# Salem Flood Map Revisions

Sean W. Kelley, P.E.

Applied Coastal Research and Engineering

Salem Panel 5 - Winter Island  
Proposed FIRM Changes  
June 30, 2016

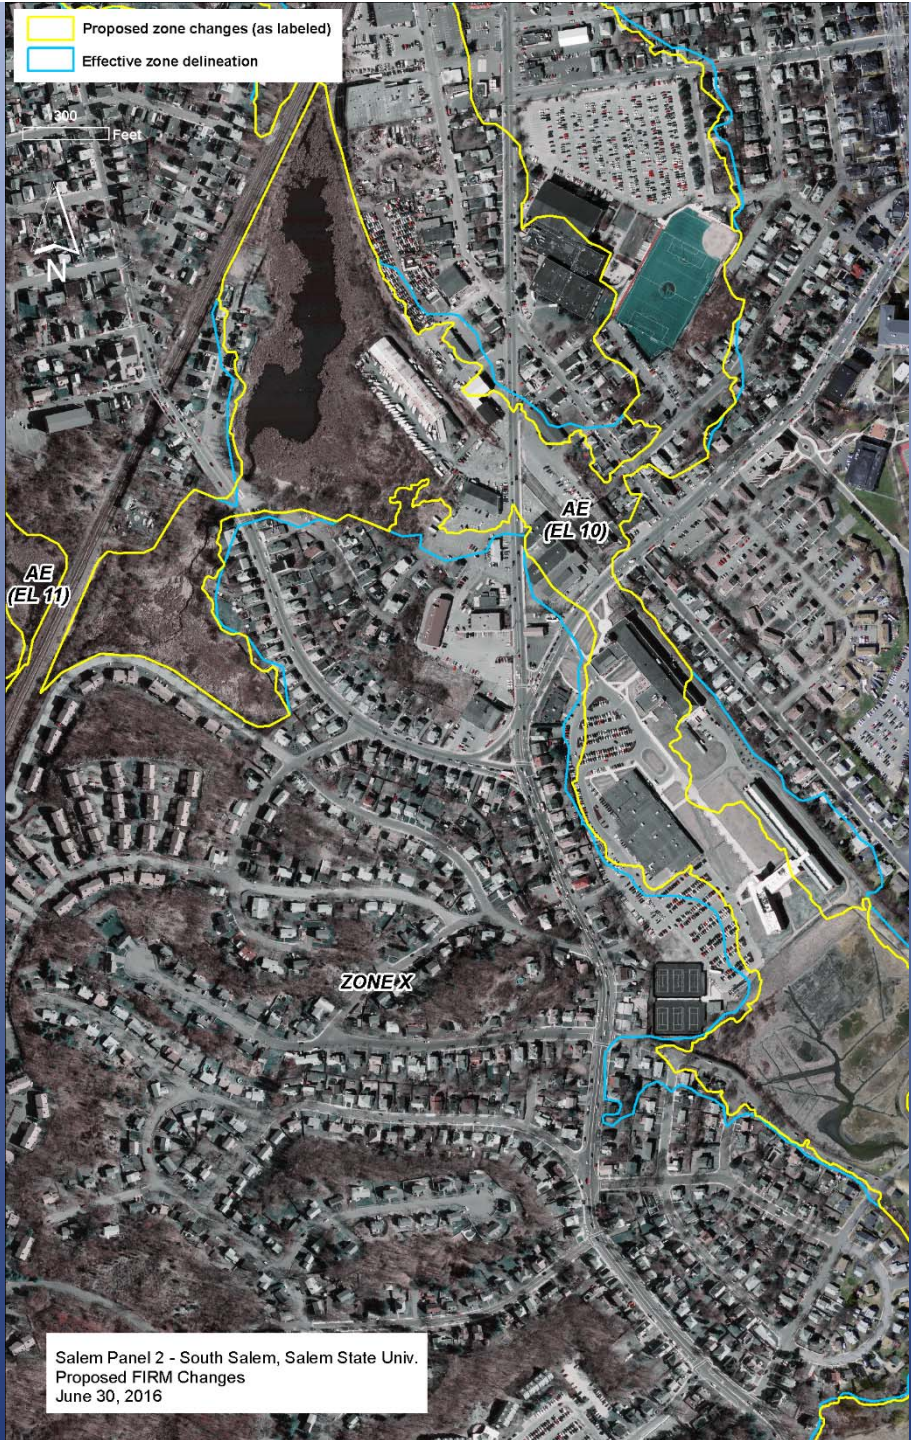
- Juniper Point & Winter Island
  - Lower VE zone elev. (21 ft reduced to 16 ft NAVD)
  - Reduce VE zone extent
  - Lower AE zone elev. (14 ft reduced to 11 ft NAVD)
  - Expanded zone X (out of 1% floodplain)
- South Salem & Forest River
  - Lower AE zone elev. (11ft reduced to 10 ft NAVD)
  - Reduced area of AE zone.
